POLYETHYLENE  
AND  
ITS SUITABILITY FOR USE IN  
HIGH INTEGRITY CONTAINERS

SCDHEC

BUREAU OF RADIOLOGICAL HEALTH

APRIL 28, 1987

STRESS TO RUPTURE OR INITIATE NECKING - HDPE (UNIRRADIATED)

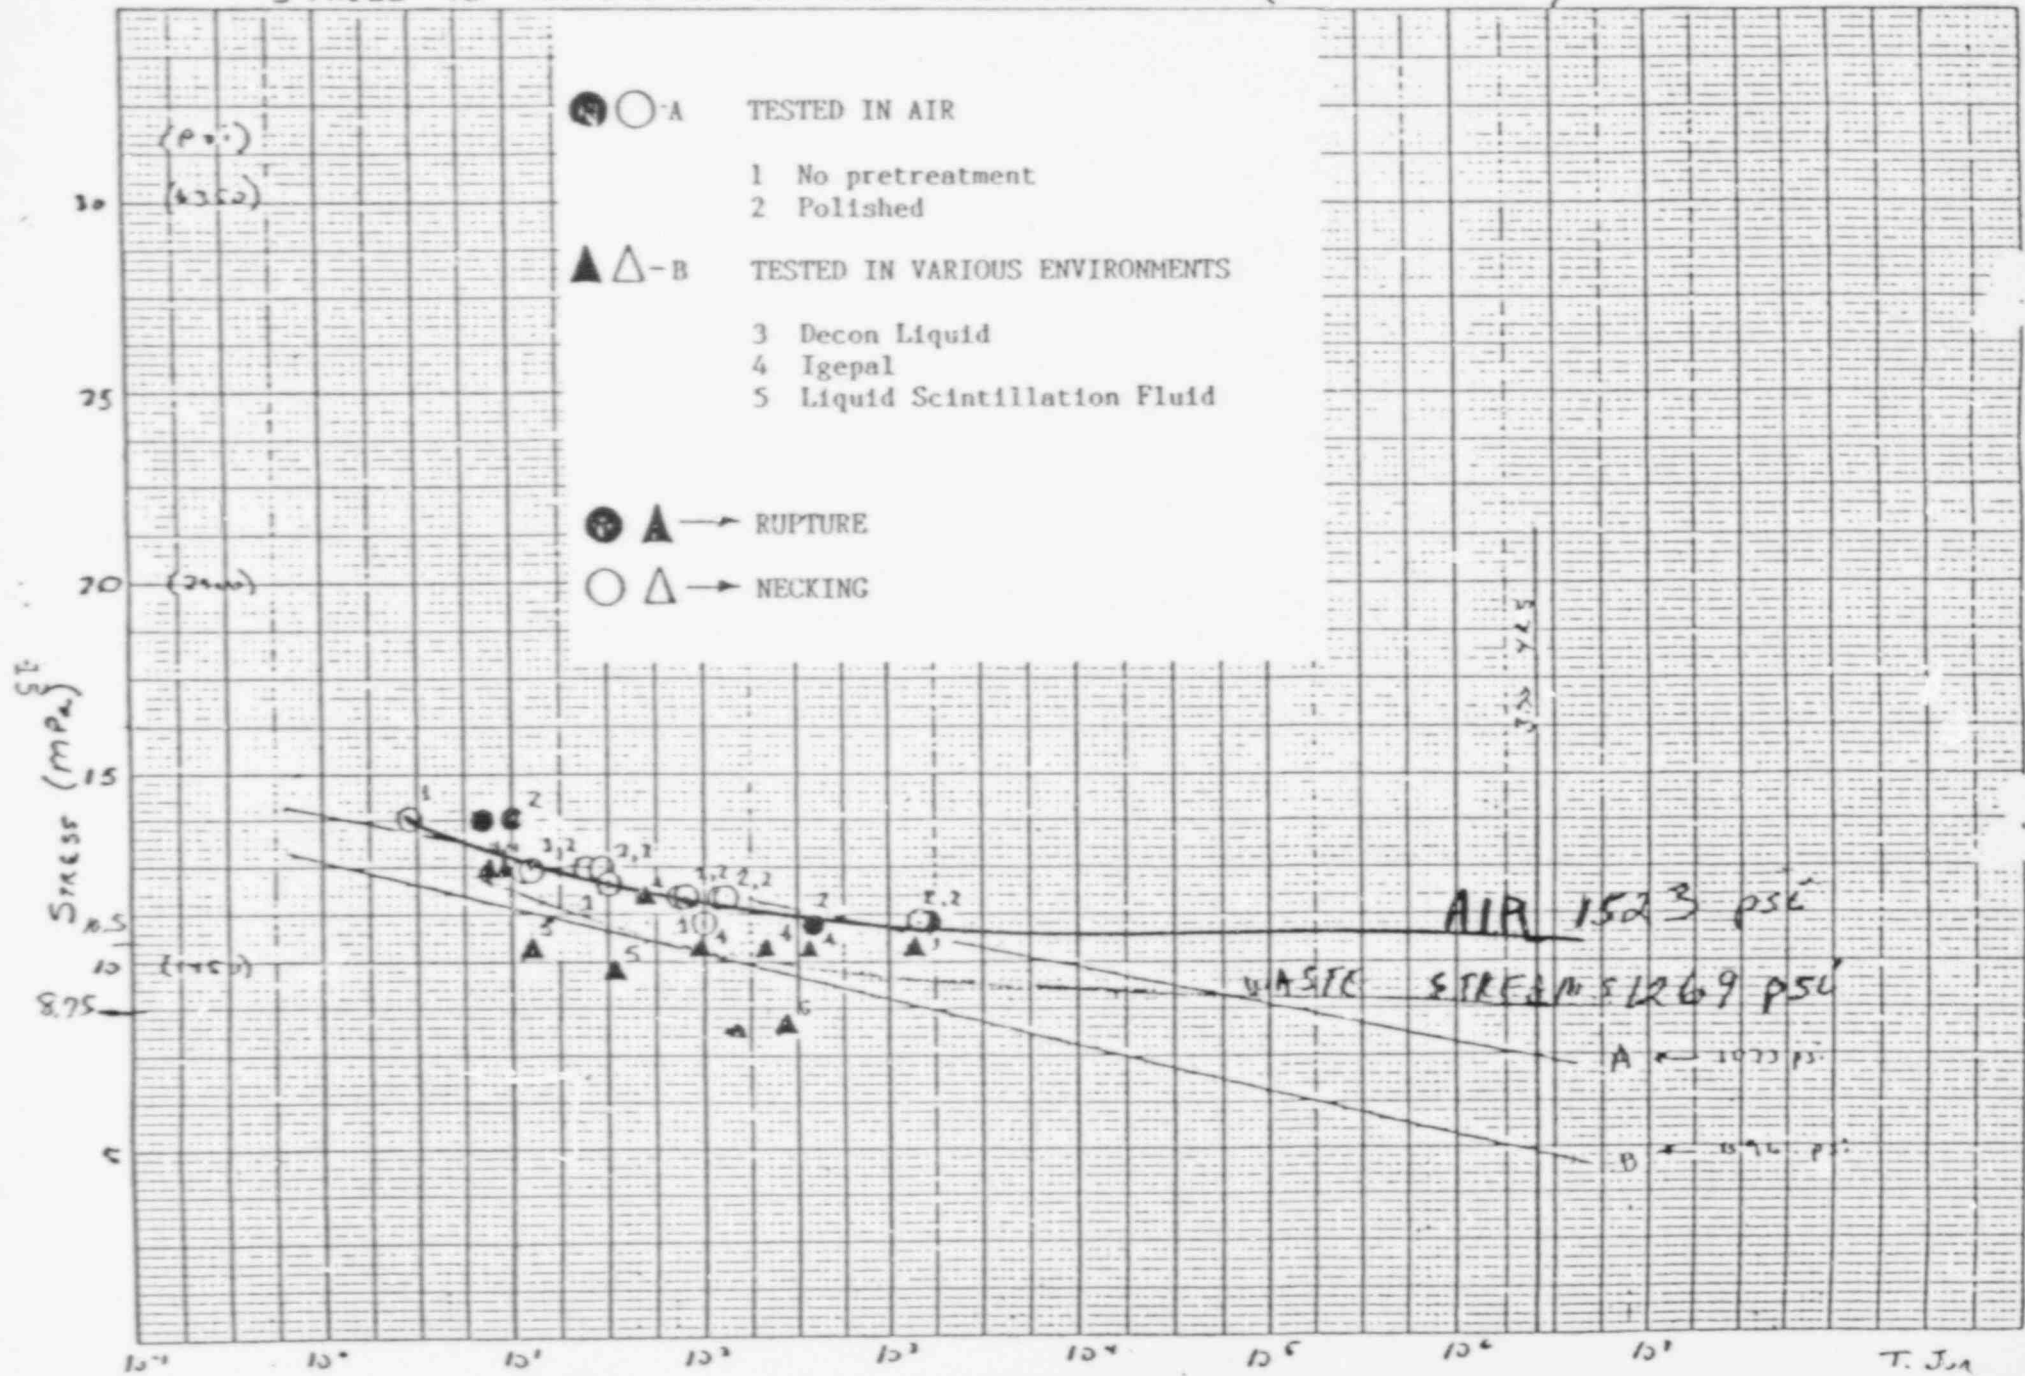
Vendor Response B: Three vendors pointed out that the curve provided by the EDTC report shows a stress rupture value of approximately 2100 psi, but it indicated that a value of 700 psi should be used for design purposes. All vendors feel this is overly conservative, and most of the containers are under 700 psi anyway.

Vendor Response C: In reference to the number of points used for extrapolation to 300 years, one vendor pointed out that there are just as many data points for irradiated and non-irradiated samples, the latter of which the EDTC report uses for the 700 psi value. Also, a linear plot may not be valid. A curve may be more appropriate, and this would yield a value twice that given by EDTC.

BRH Response: BRH believes that the strength value of 700 psi is not a valid assumption. The linear plot in the EDTC report may not be accurate (ref.3). The points for the non-irradiated samples tend to fit a curve which would yield a value higher than the value given by EDTC, approximately 1523 psi for samples tested in air and 1259 psi for the samples exposed to various waste streams. We feel that the value of 2100 psi for the irradiated samples is valid until proof can be provided otherwise.
